### PLANNING COMMISSION AGENDA

**Thursday, June 18, 2020**

3.3. Request: Preliminary Plat approval for Mountain Ridge Phases 1-2, including 94

# Mountain Ridge Engineering DRC Comments June 2, 2020

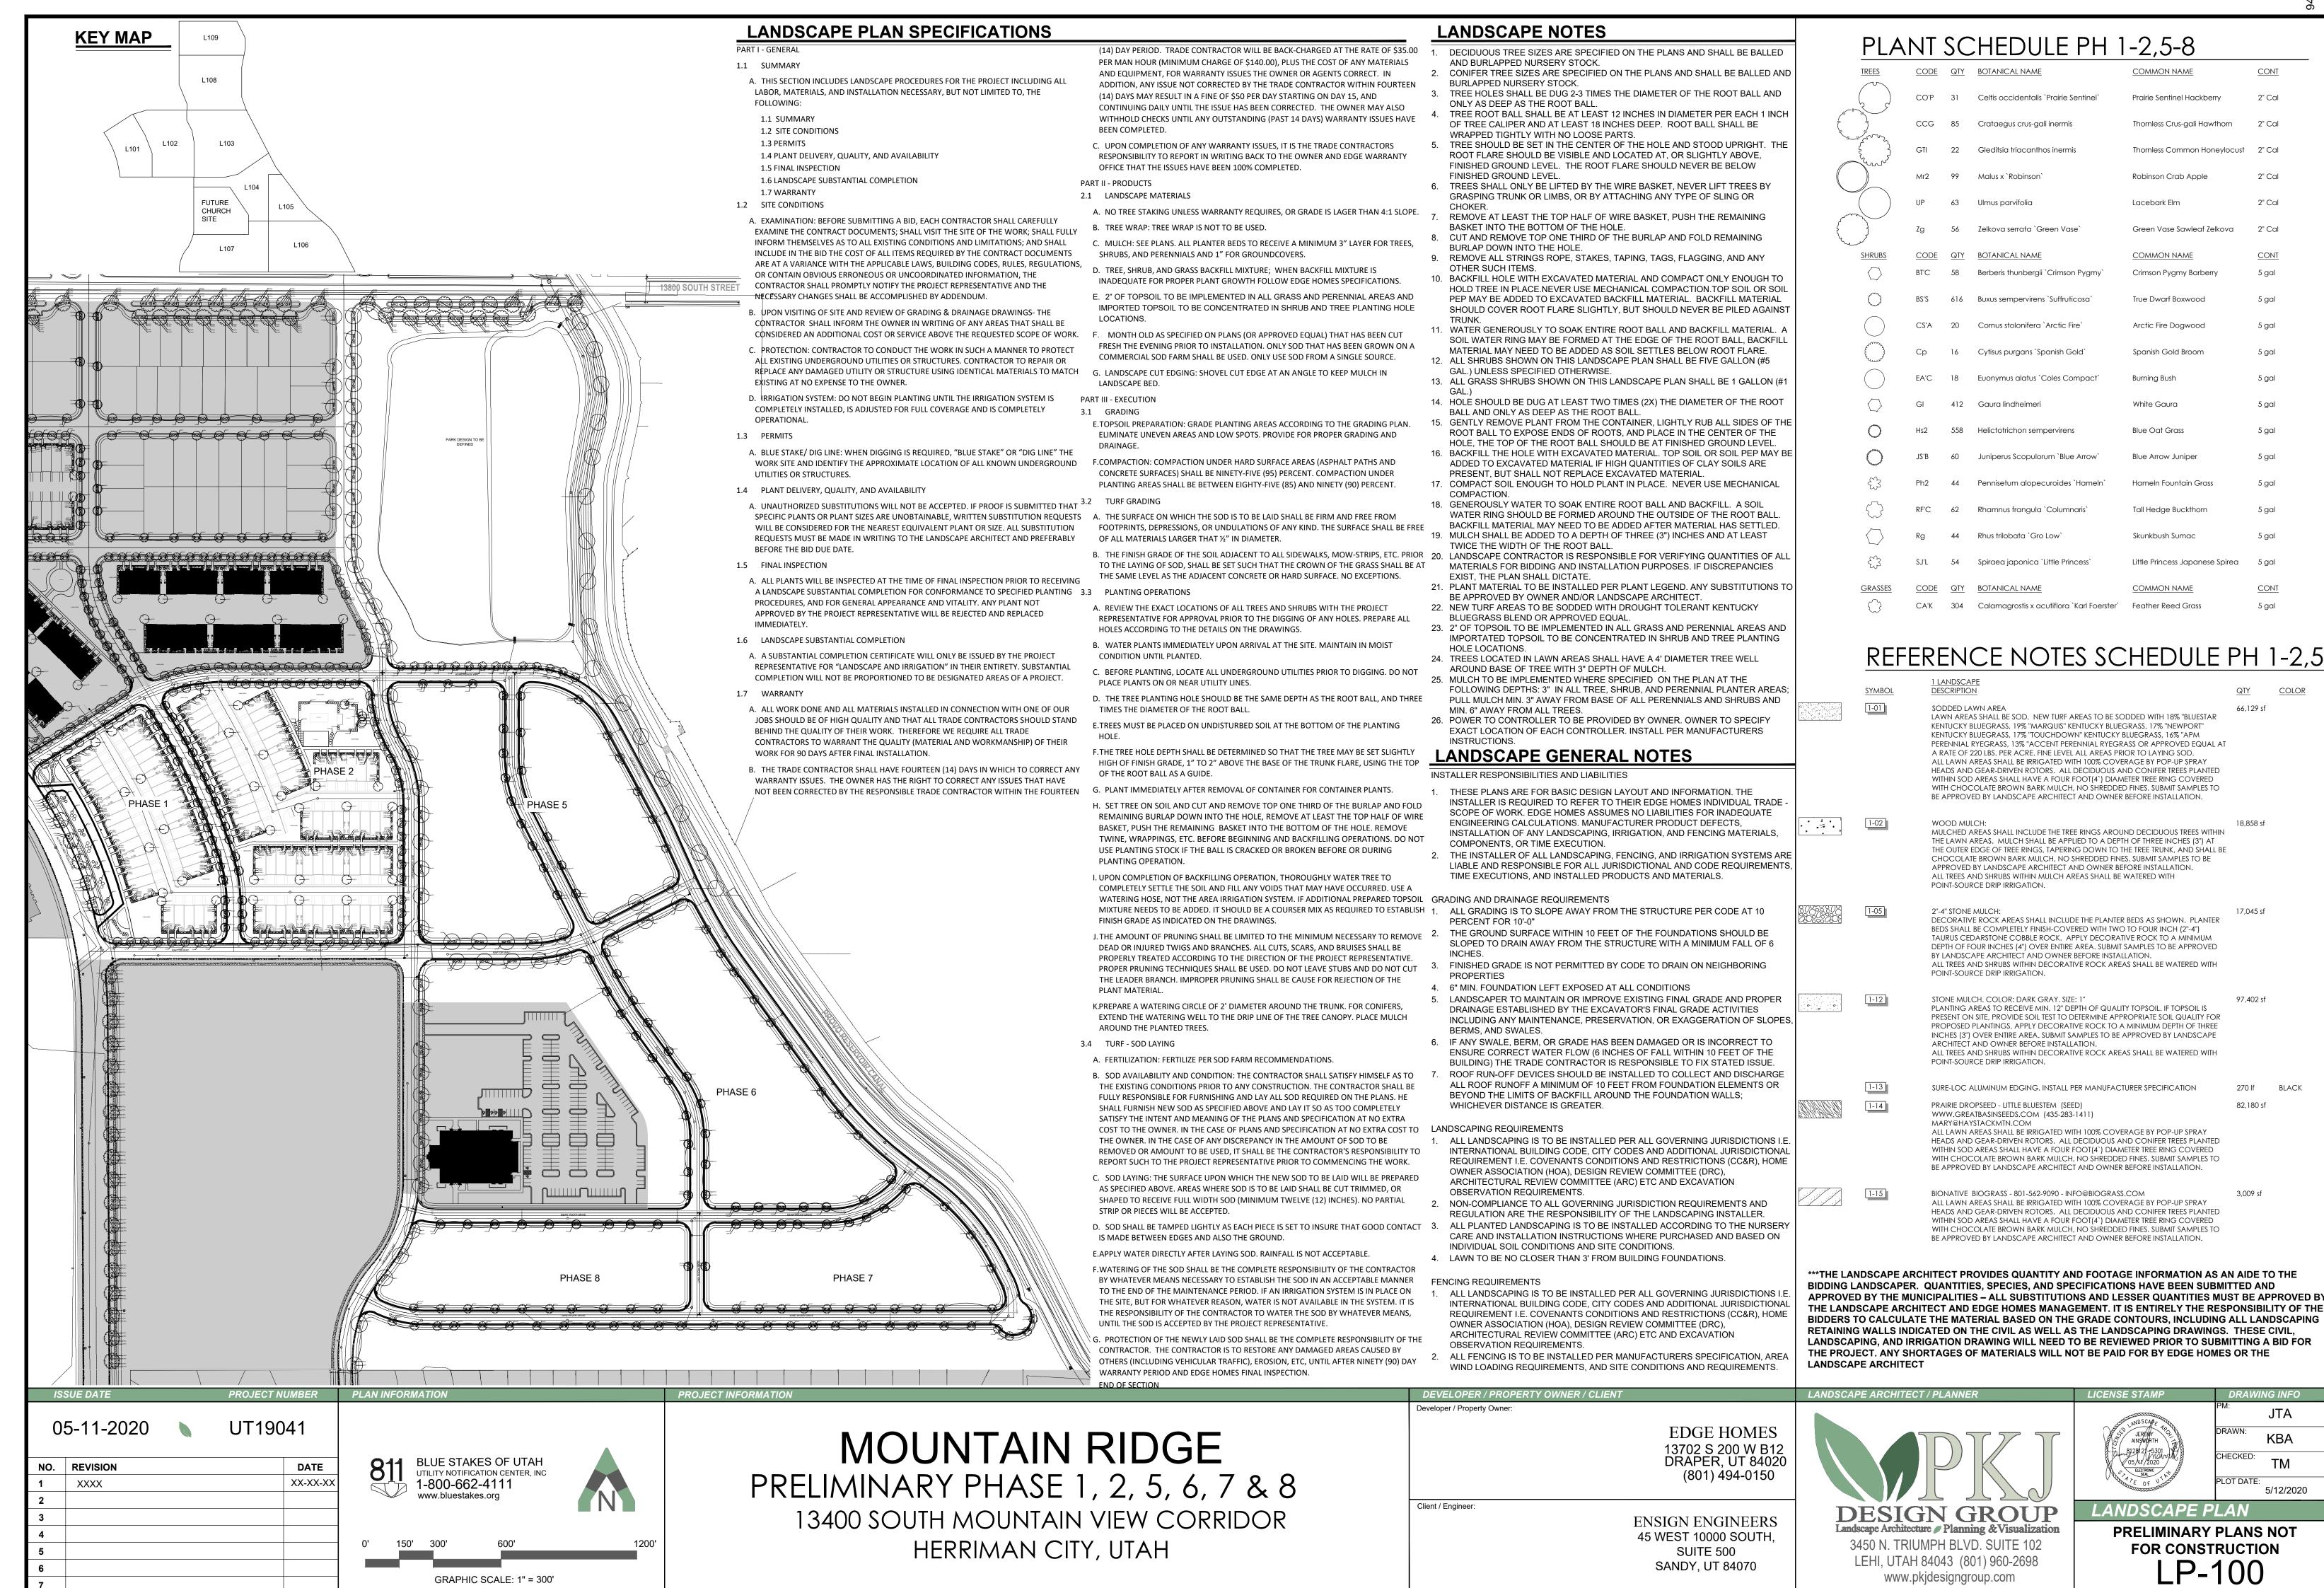
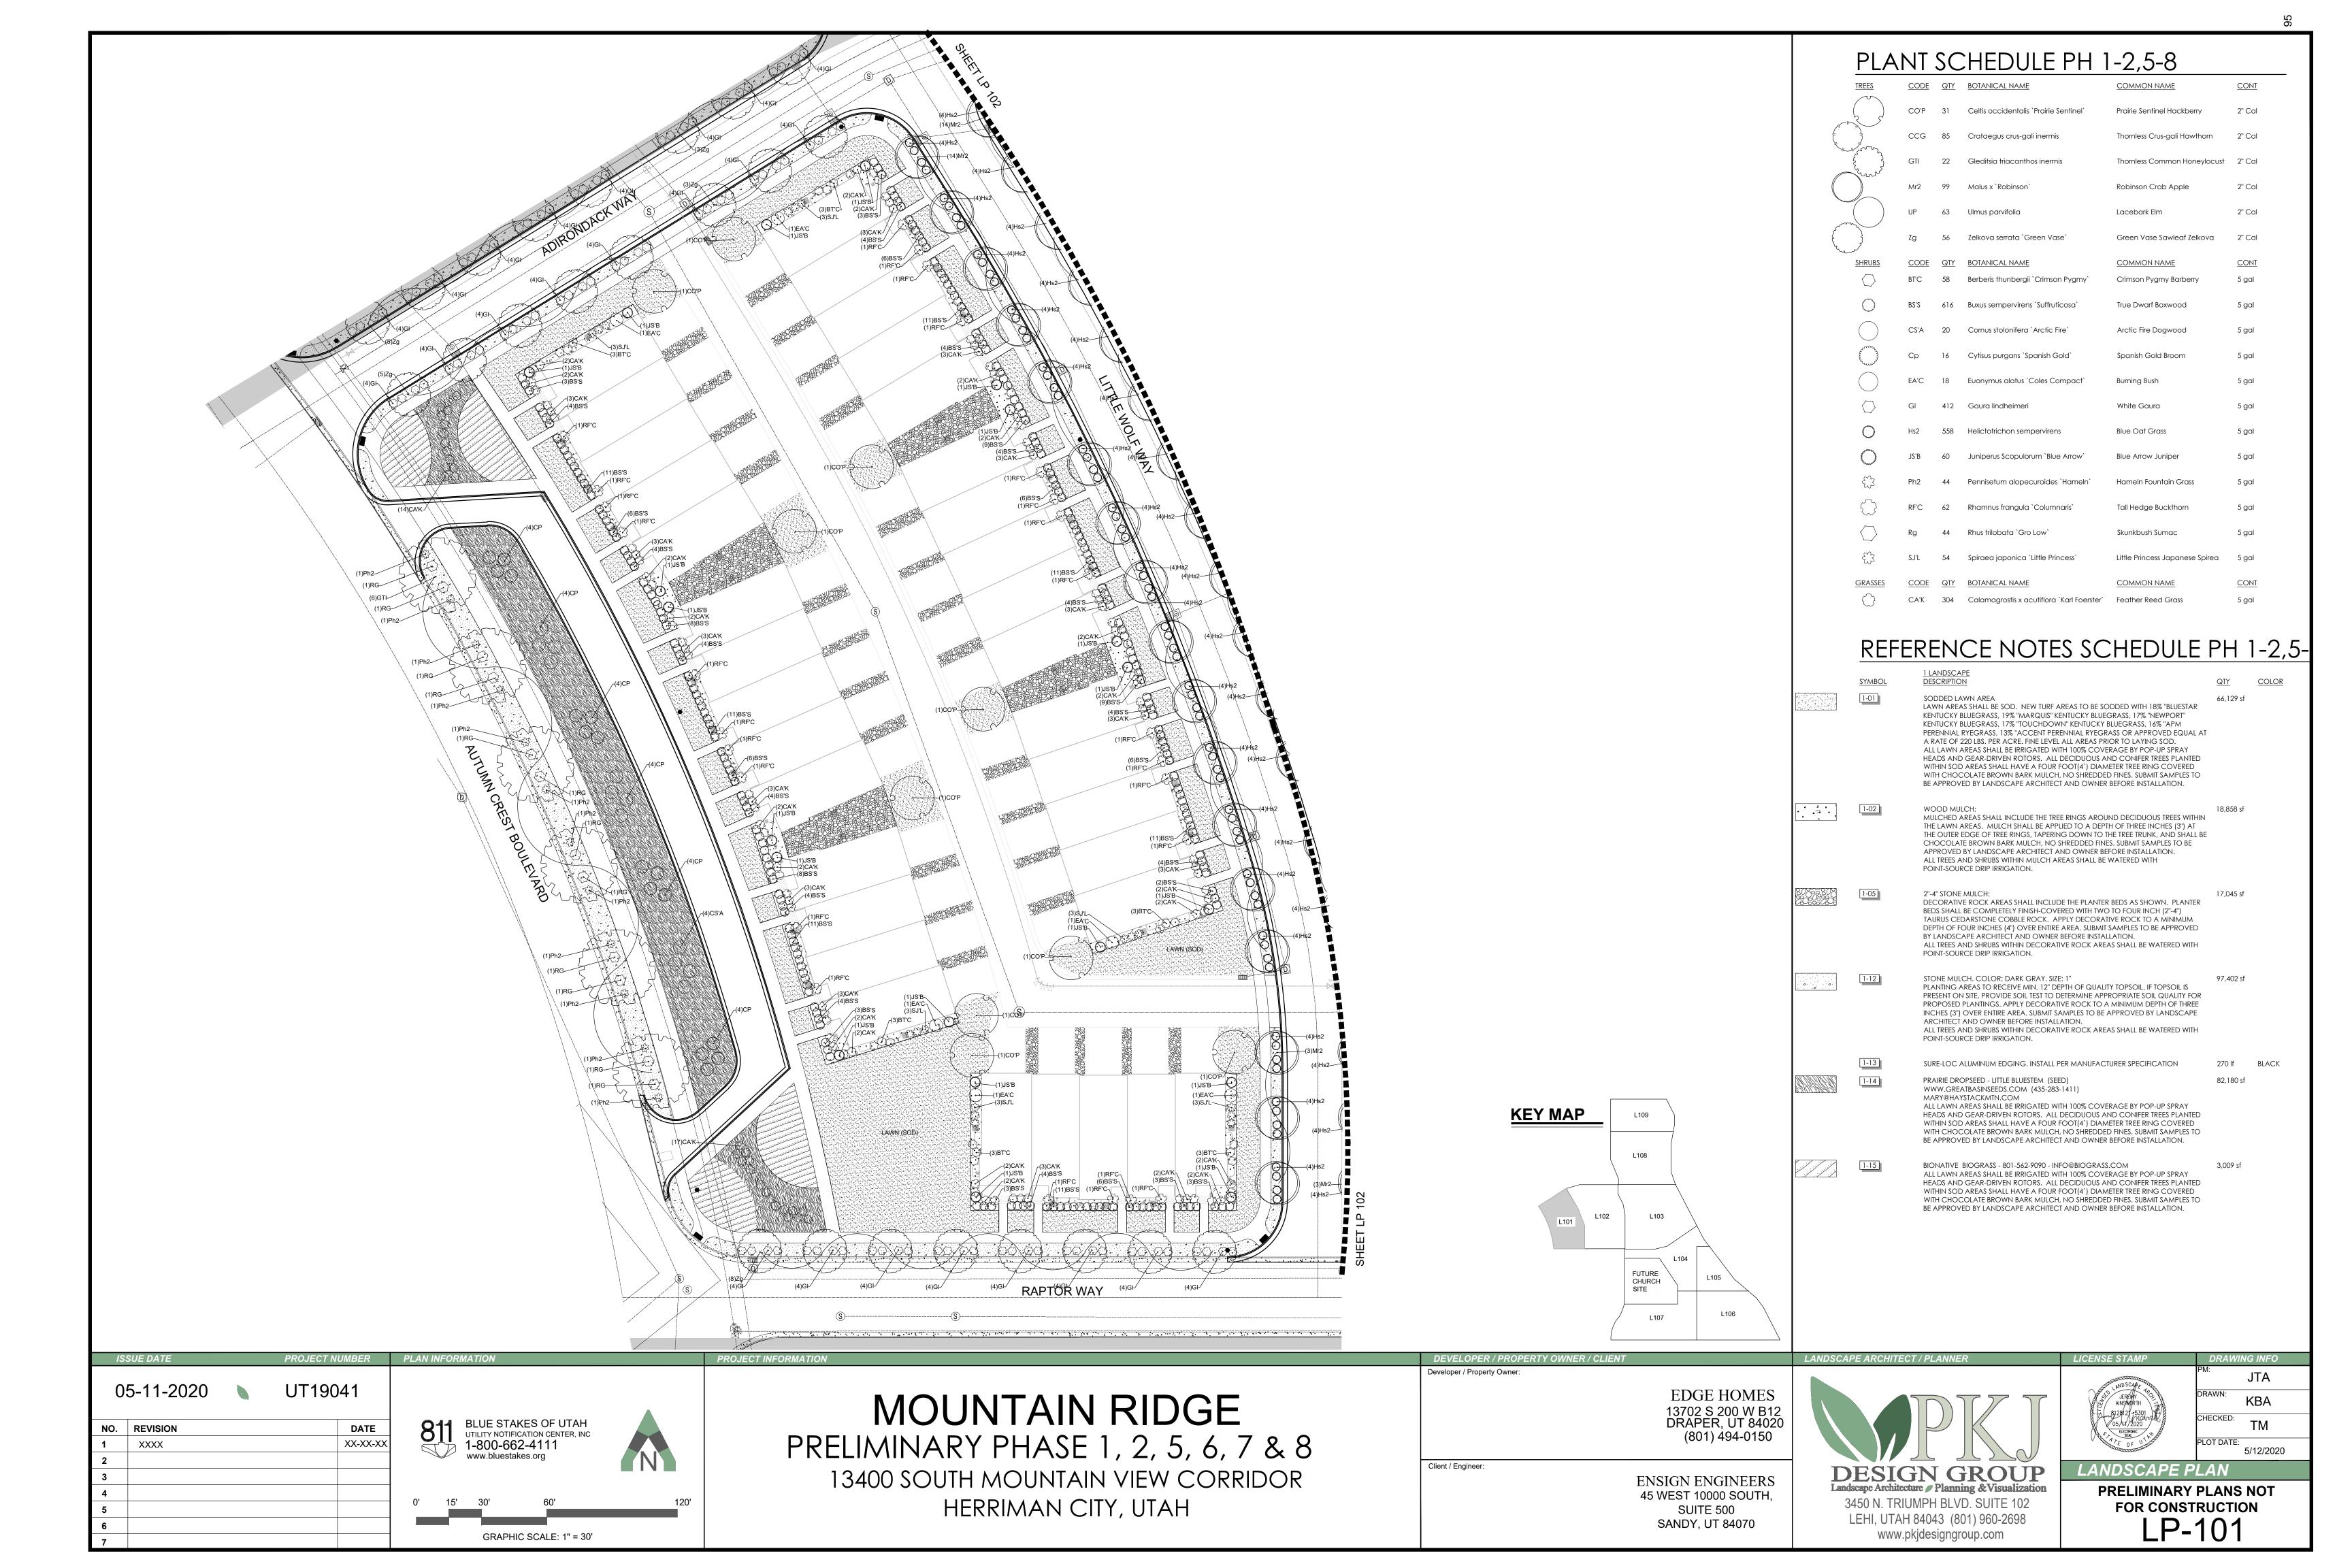
- Show locations of fire hydrants on utility plans.
- Temporary turnaround may be required between phase 7 and 8 depending on timing.
- Private drives and alleys will need to be signed no parking on both sides due to width.
  - o Entrances and 150' intervals.
- Provide road cross sections details.

- Improvements to all public streets to include sidewalk, curb and gutter, landscaped parkstrips to city standards, and city standard lighting.
- Show all road cross sections.

- Include civil details including road improvements, trails, etc.
- Project will need a development drainage master plan for the entire development for review.

- Will ditch be piped in future.
- How will 10 acre park be developed in multi phased approach for detention.
- Include nuisance by-pass piping to prevent muddy bottom in 10 acre park.

- NOI required.
